DART AEROSPACE LTD		Work Order:	65032
Description: Crosstube Low Aft (412)		Part Number:	D412-664-209
Inspection Dwg: D412-664-249	Rev: B	Page 1 of 1

DRAWING NO. D412-664-249	TITLE CROSSTUBE ASS'Y (412 LOW AFT)	REV. B	DART AEROSPACE LTD ENGINEERING ORDER		D.E.O. NO. D412-664-249-B-1	SHEET NO. SHEET 1 OF 2	SCALE NTS
DRAWN <i>92</i>	CHECKED <i>Sc</i>	MFG. APPR. <i>E</i>	APPROVED <i>MD</i>		DE APPR. <i>MD</i>		
DATE 11.05.25	DATE 11.05.31	DATE 11.05.31	DATE 11/05/31		DATE 11.05.31

DRAWING NO. D412-664-249	TITLE CROSSTUBE (412 LOW AFT)	REV. B	DART AEROSPACE LTD ENGINEERING ORDER		D.E.O. NO. D412-664-249-B-3	SHEET NO. SHEET 1 OF 3	SCALE NTS
DRAWN <i>qp</i>	CHECKED <i>a</i>	MFG. APPR. <i>DD</i>	APPROVED <i>AD</i>		DE APPR. <i>#</i>		
DATE 12.08.21	DATE 12.08.30	DATE 12.08.30	DATE 12.08.30		DATE 12.08.30

D412-664-249
ASSEMBLY DETAIL

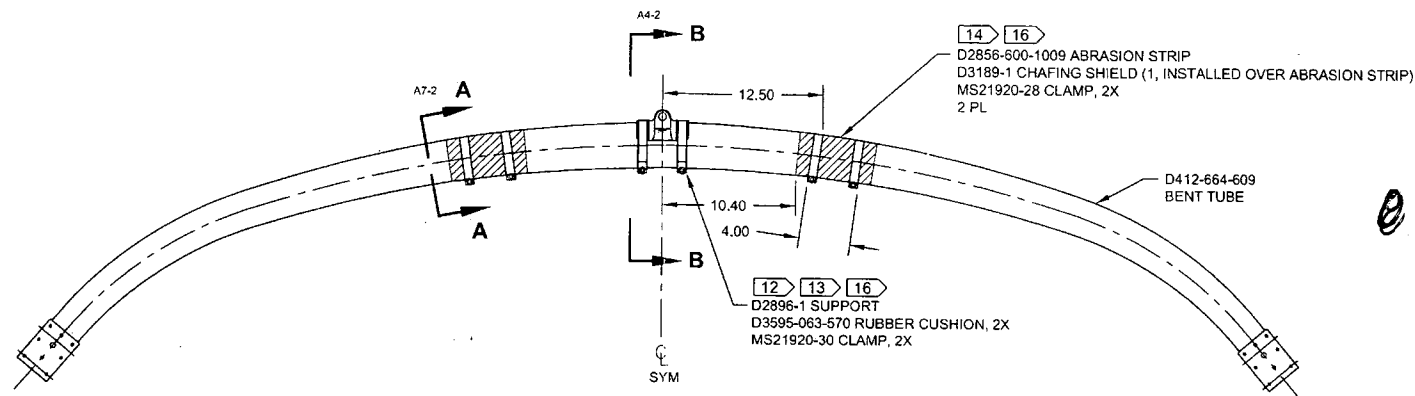
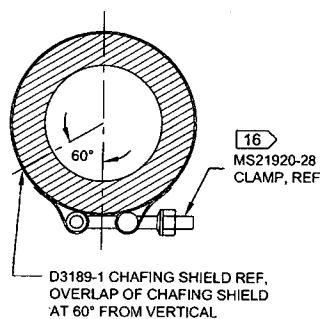
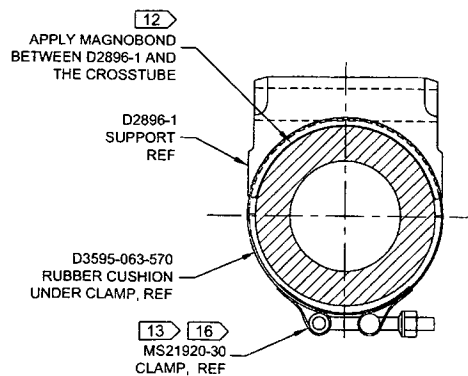
CHANGE:

NOTE 14, SHEET 1 IS AMENDED AS FOLLOWS:

SECTION A-A
CHAFING SHIELD DETAIL
VIEW ROTATED, NOT TO SCALE

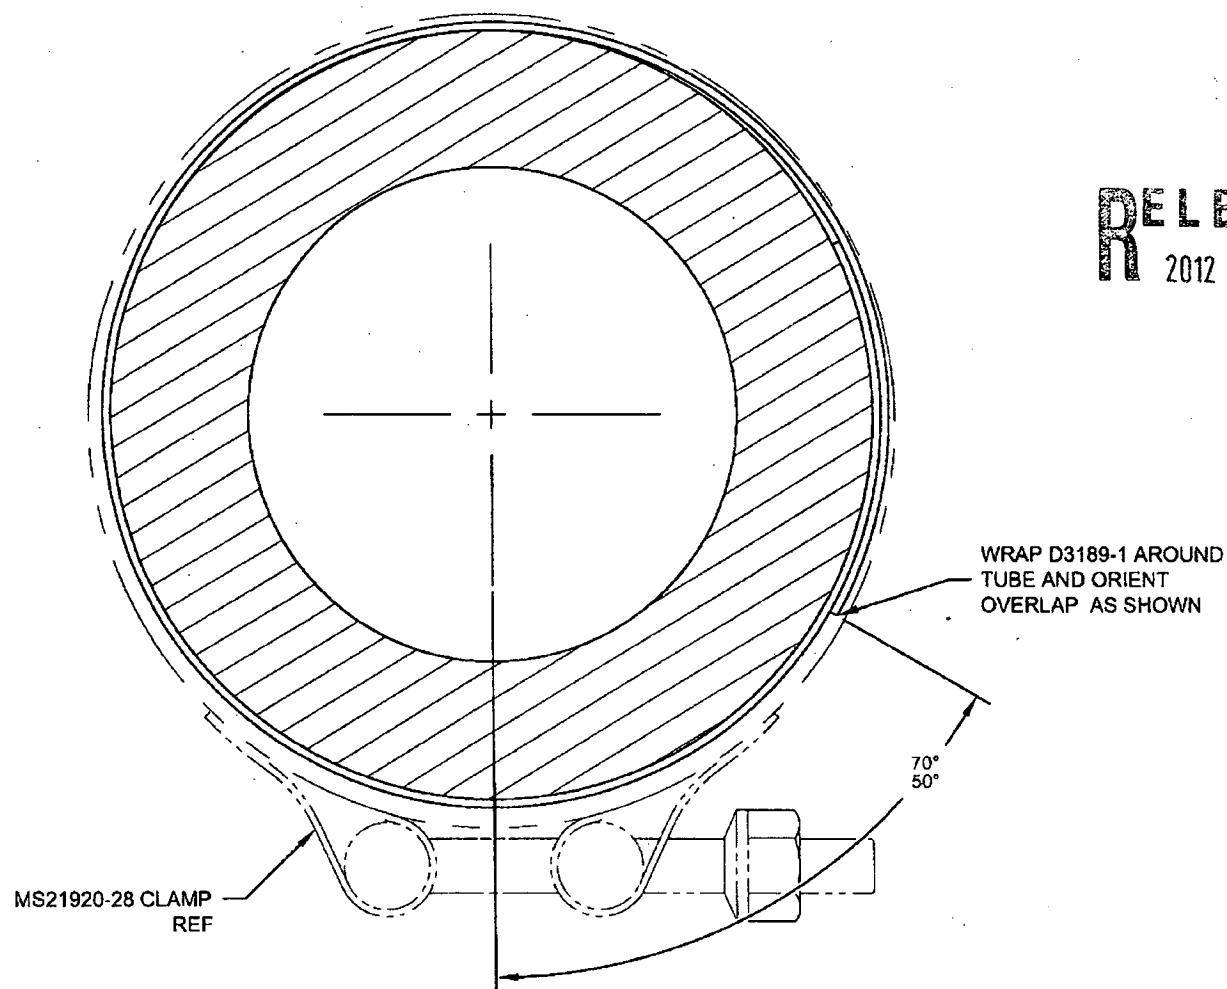
CHANGE:

NOTE 14 AND 16 ON SHEET 1 IS AMENDED AS FOLLOWS:
